ITEM FOR ENVIRONMENTAL COMMISSION AGENDA

NAME & NUMBER OF PROJECT: 6420 Bee Caves Road
SP-2018-0299D

Staff Findings of Fact and Exhibits

ENVIRONMENTAL COMMISSION VARIANCE APPLICATION FORM

6420 BEE CAVE ROAD
CUT AND FILL EXHIBIT

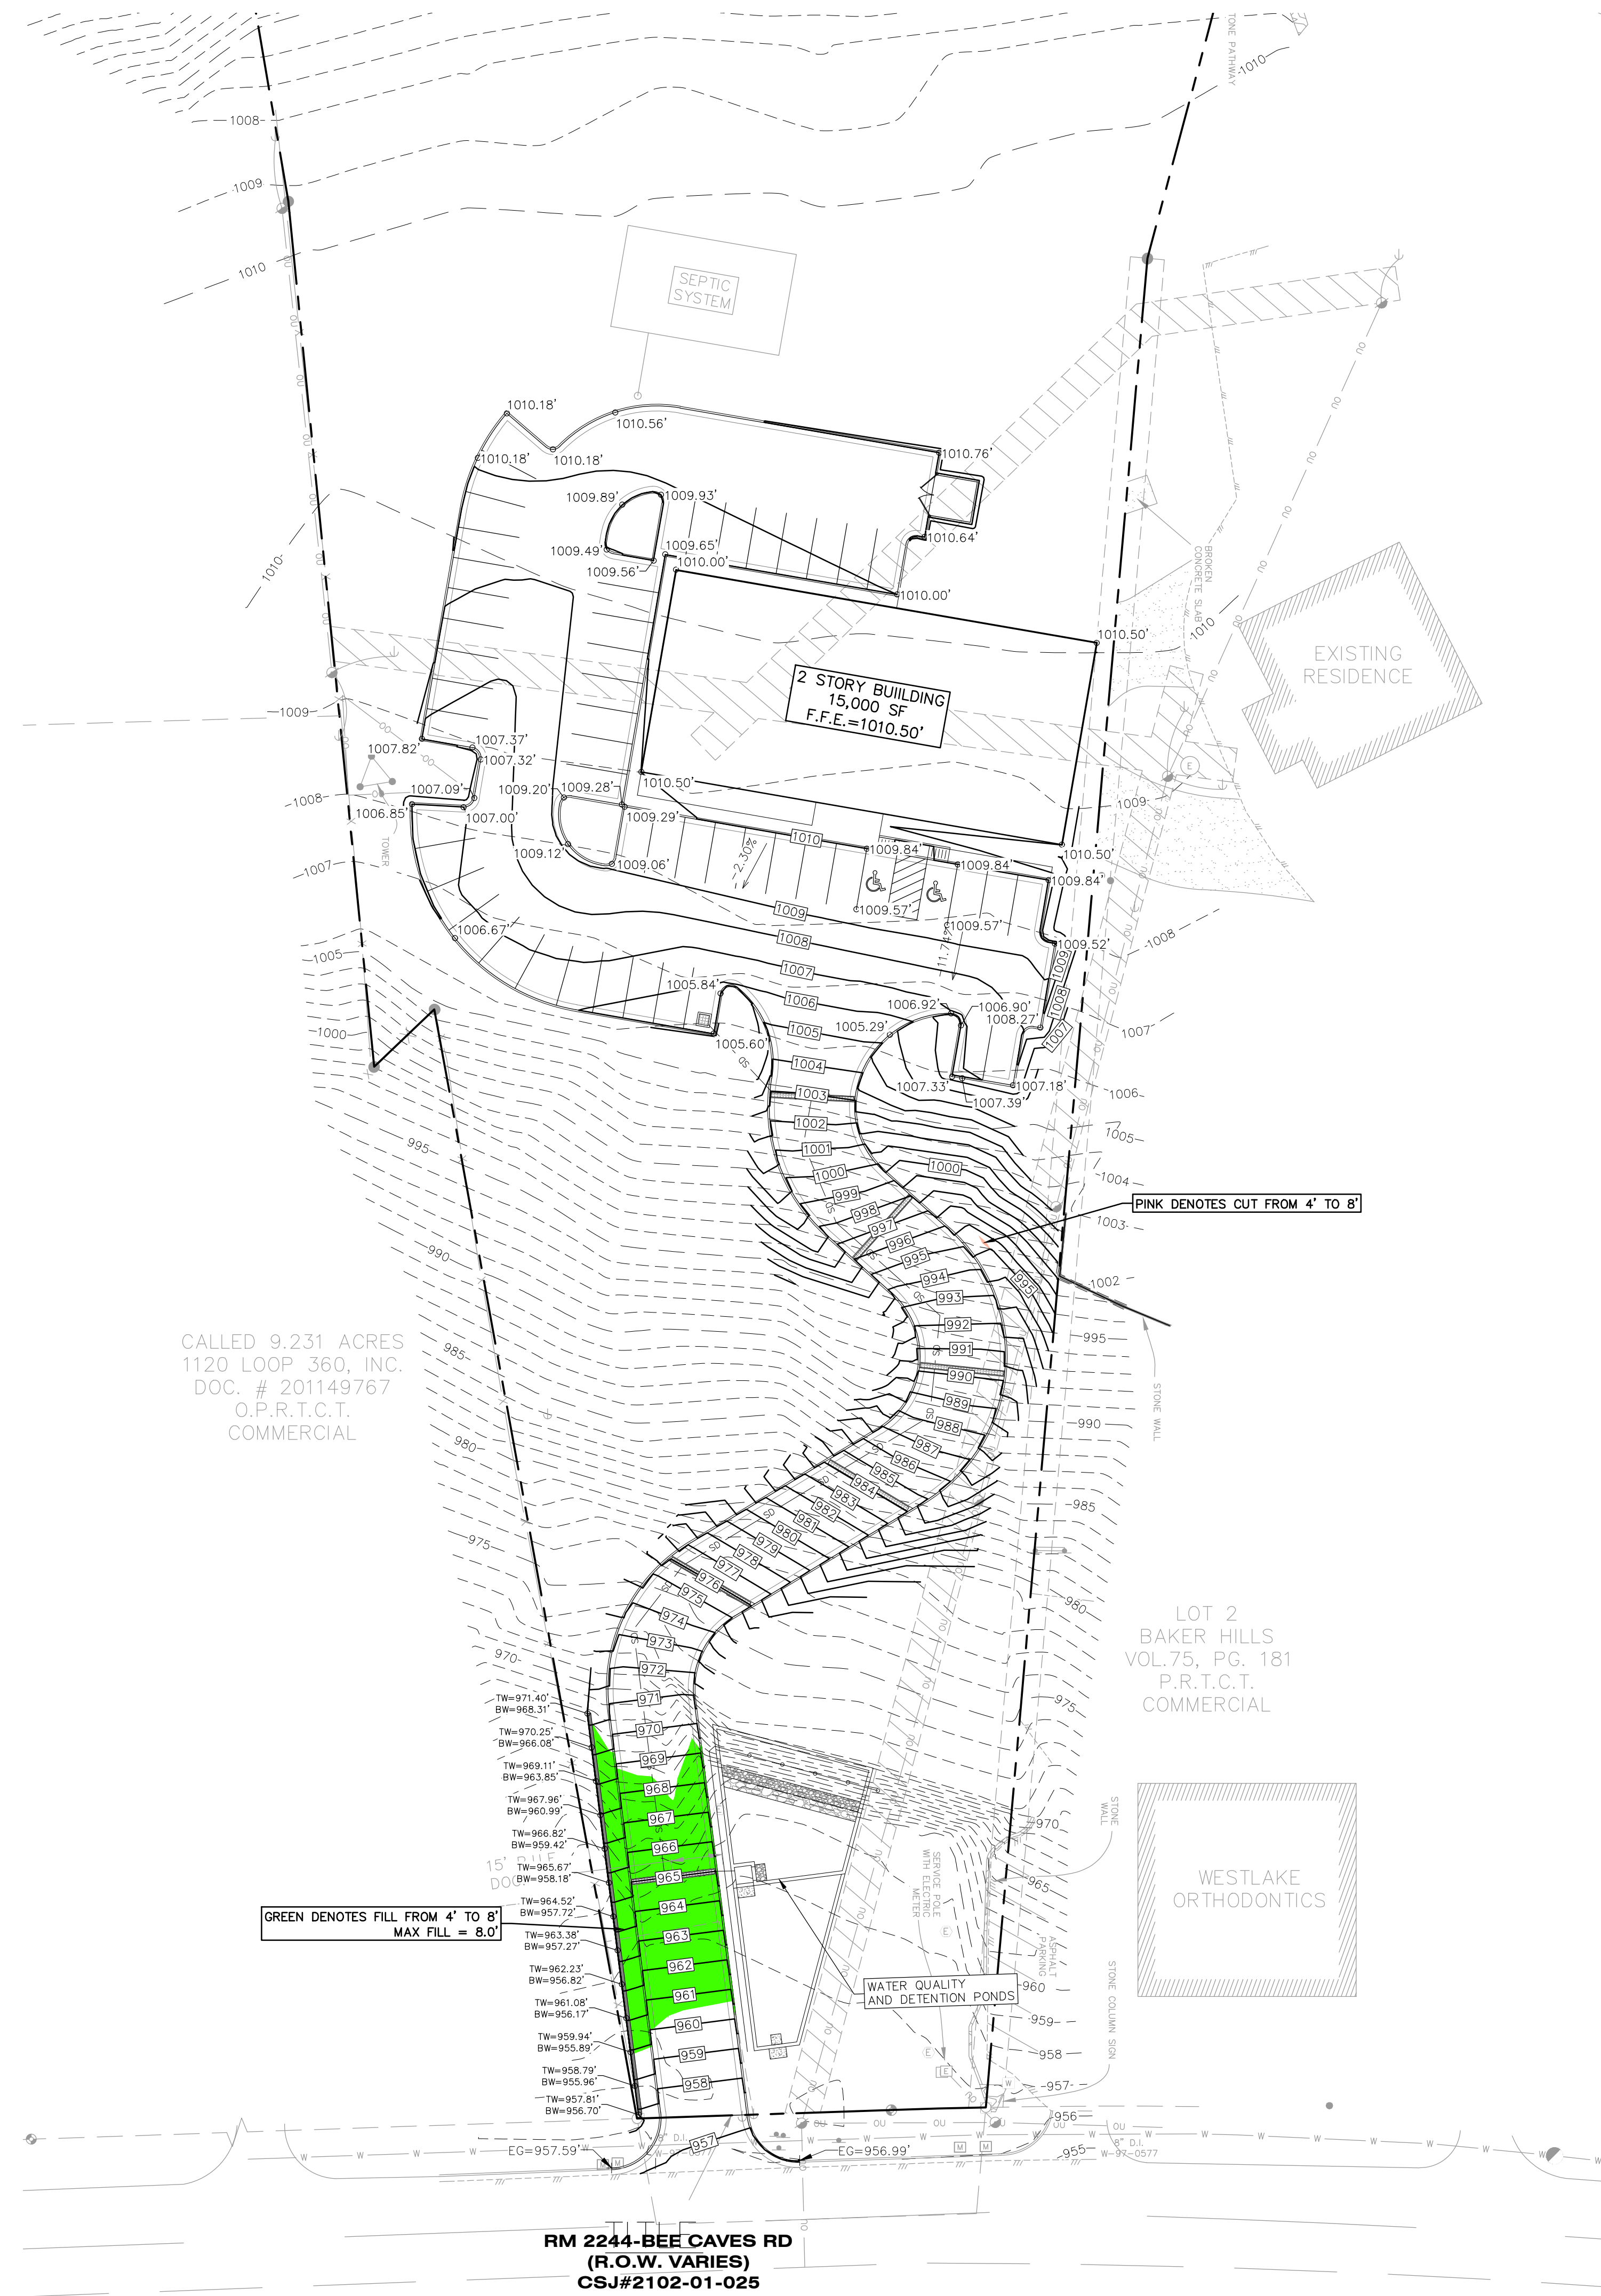
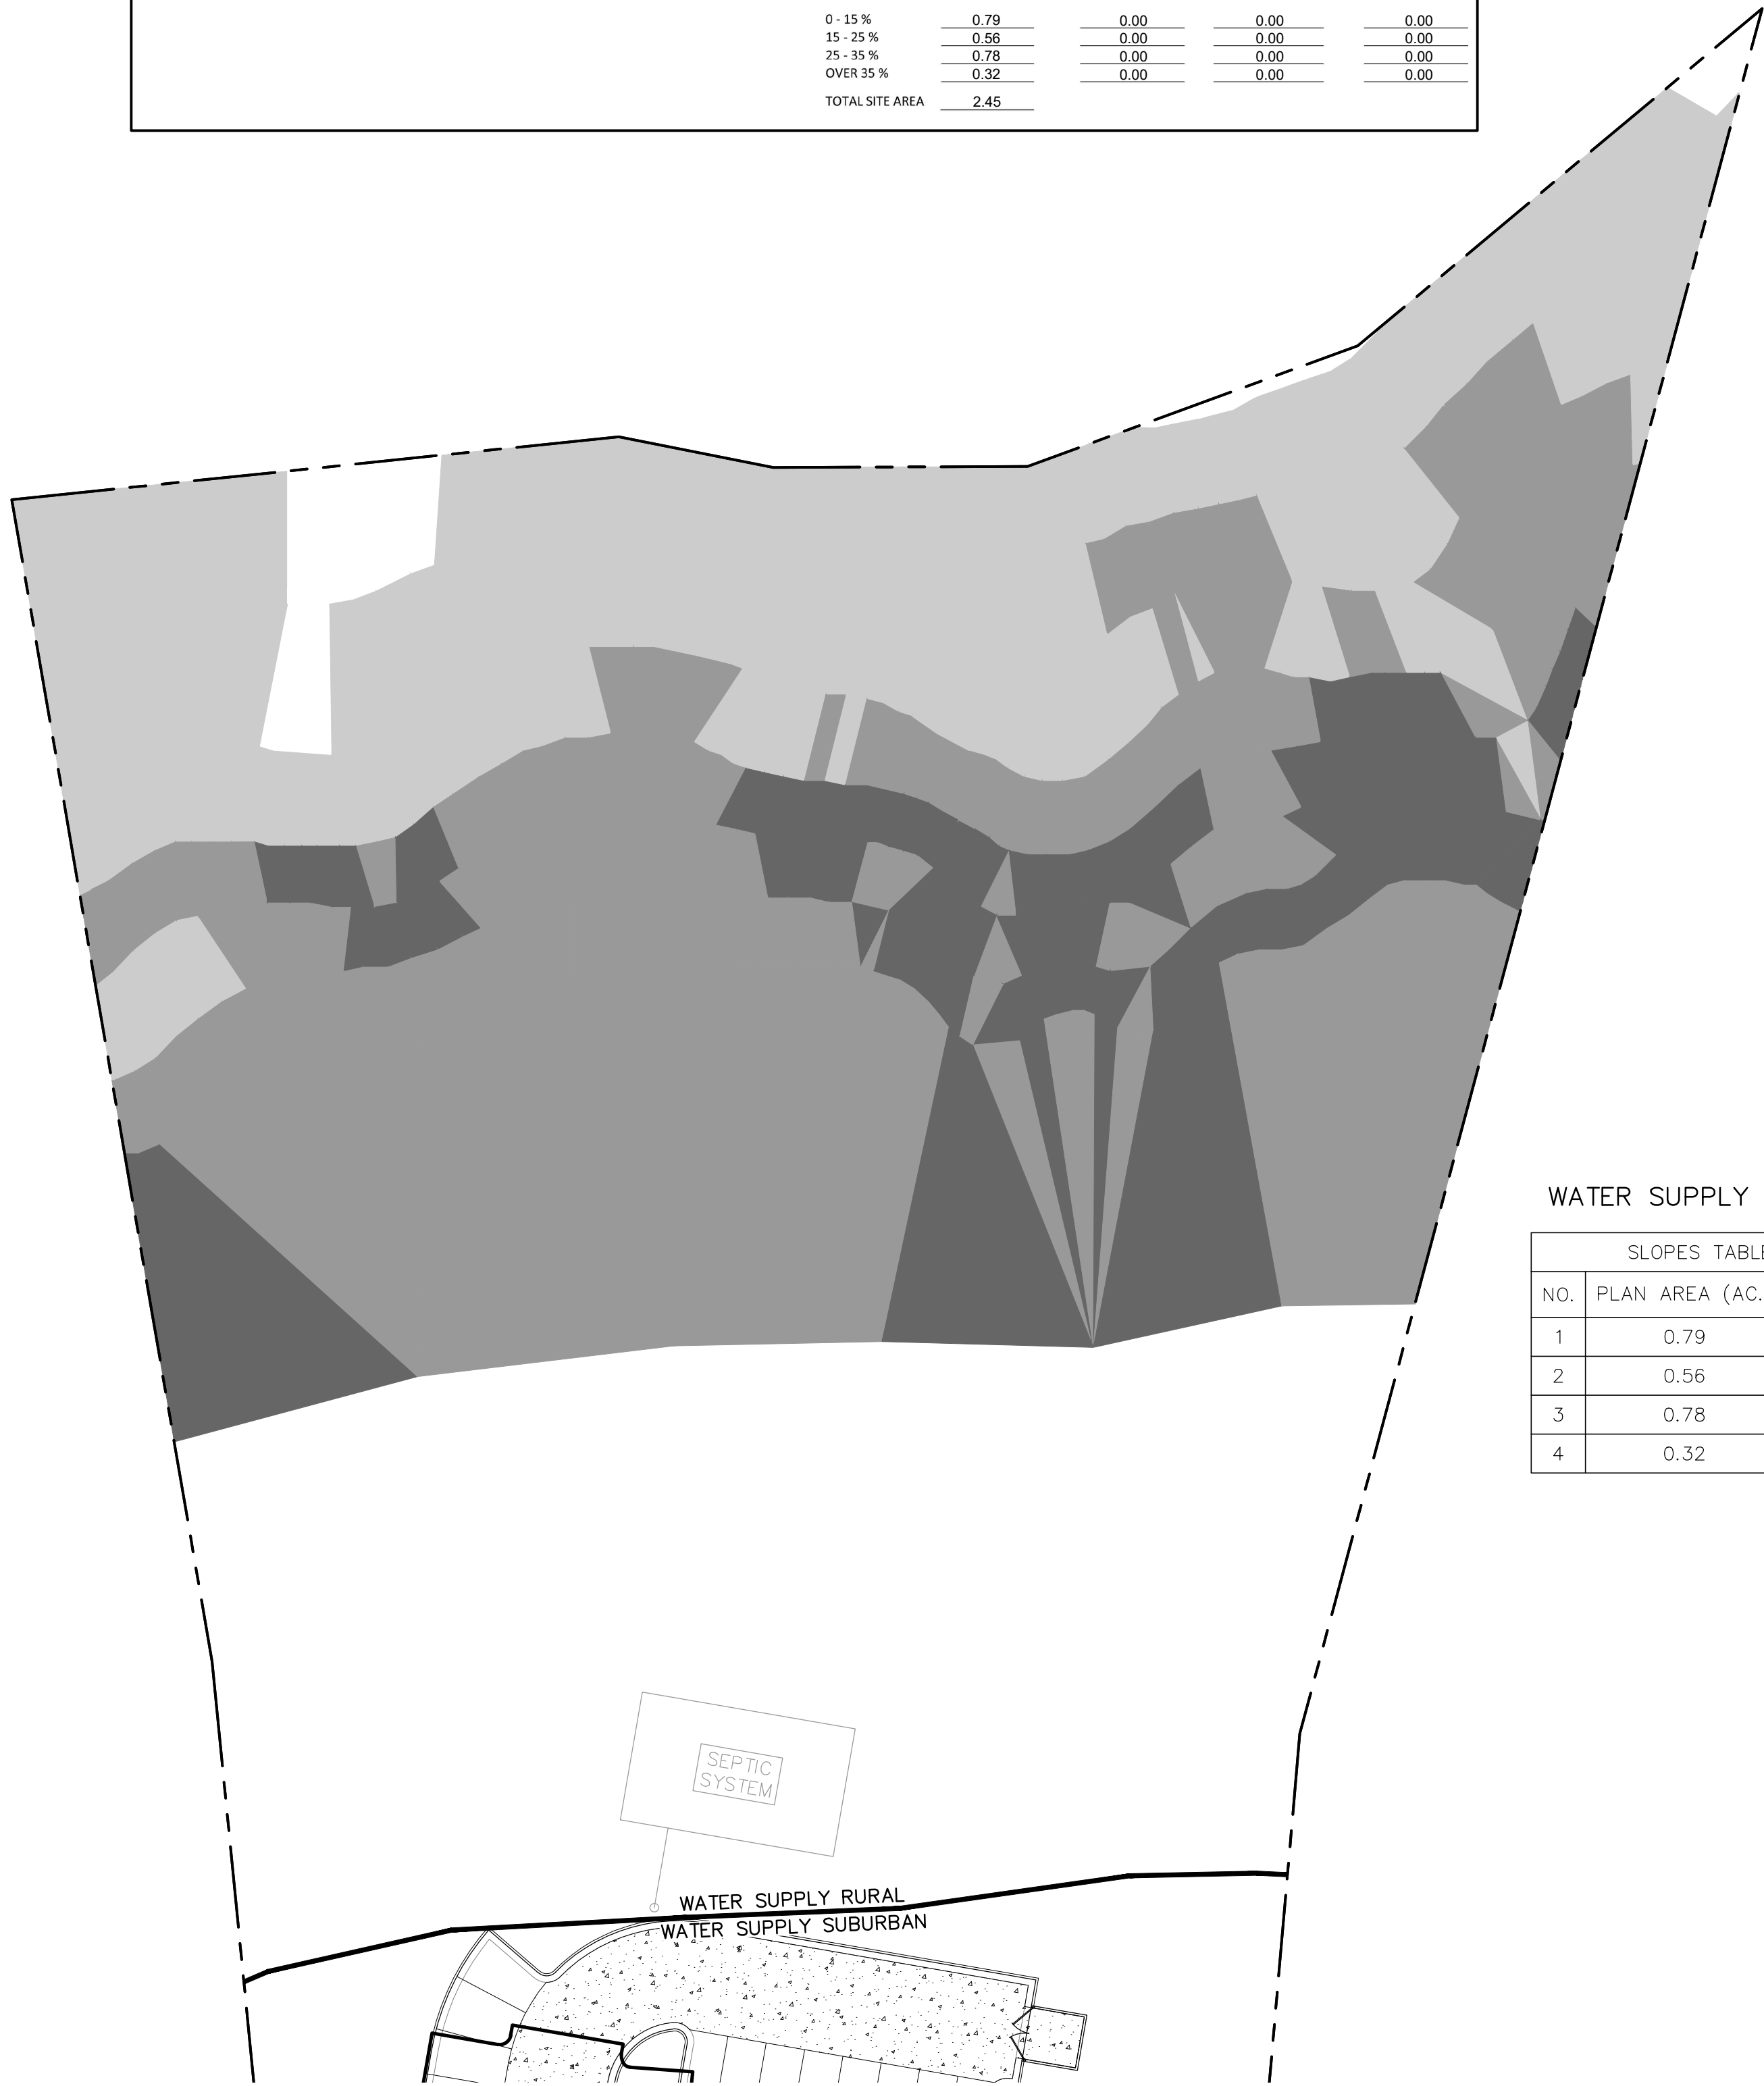
Yes. The variance is required to access the flatter, more buildable portion of the site. Because of the need to construct a driveway across the steep slopes in order to access the buildable portion of the site, a variance for cut in excess of four feet of depth is required in order to obtain access and meet slope and cross-slope requirements for driveway construction.

Yes. The amount of cut exceeding four feet in depth required to access the buildable portion of the site, and to ensure constructability of the access drive, is approximately four square feet.

Yes. The variance is required to access the flatter, more buildable portion of the site. Because of the need to construct a driveway across the steep slopes in order to access the buildable portion of the site, a variance for fill in excess of four feet of depth is required in order to obtain access and meet slope and cross-slope requirements for driveway construction.

Yes. The amount of fill exceeding four feet in depth required to access the buildable portion of the site, and to ensure constructability of the access drive, is approximately 2,650 square feet (~1.35 percent of the gross site area).

Staff Determination: Staff determines that the findings of fact have been met. Staff recommends the following condition: tree mitigation in accordance with current Land Development Code and Environmental Criteria Manual requirements.

Staff Determination: Staff determines that the findings of fact have been met. Staff recommends the following condition: tree mitigation in accordance with current Land Development Code and Environmental Criteria Manual requirements.
